# UNITED STATES PATENT AND TRADEMARK OFFICE

APPLICATION NO.	FILING DATE	FIRST NAMED INVENTOR	ATTORNEY DOCKET NO.	CONFIRMATION NO.
10/523,385	02/01/2005	Johannes Otto Voorman	NL 020728	4142

<b>Office Action Summary</b>	<b>Application No.</b> 10/523,385	<b>Applicant(s)</b> VOORMAN ET AL.	
	<b>Examiner</b> Christopher R. Lamb	<b>Art Unit</b> 2627

## DETAILED ACTION

FIG. 3

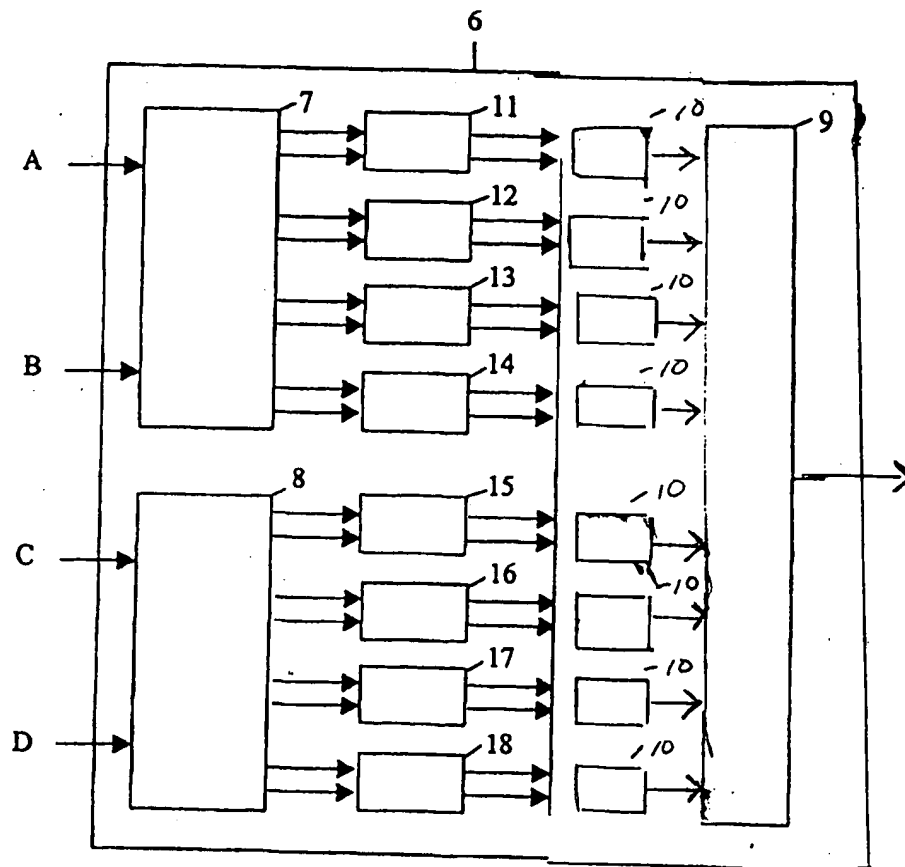
1. The amendment to the drawings was received on August 11<sup>th</sup>, 2006. These drawings are not acceptable.

The new drawing is labeled "Fig. 3." However, there is already a Fig. 3 in the Application.

2. The drawings are objected to under 37 CFR 1.83(a). The drawings must show every feature of the invention specified in the claims. Therefore, the "low pass filter located between at least one sequential-logic circuit and said at least one analog adder/subtractor" (claim 5) must be shown or the features canceled from the claims. No new matter should be entered.

(Note the amended drawing received August 11<sup>th</sup>, 2006 was clearly intended to address this objection: however, because that drawing was improperly labeled, the amended drawing was not entered).

The Examiner acknowledges that the new drawing was intended to respond to the objection to the drawings for failing to show every feature of the invention specified in the claims. However, because the new drawing was labeled "Fig. 3" and there is already a "Fig. 3," the amended drawing was not entered.
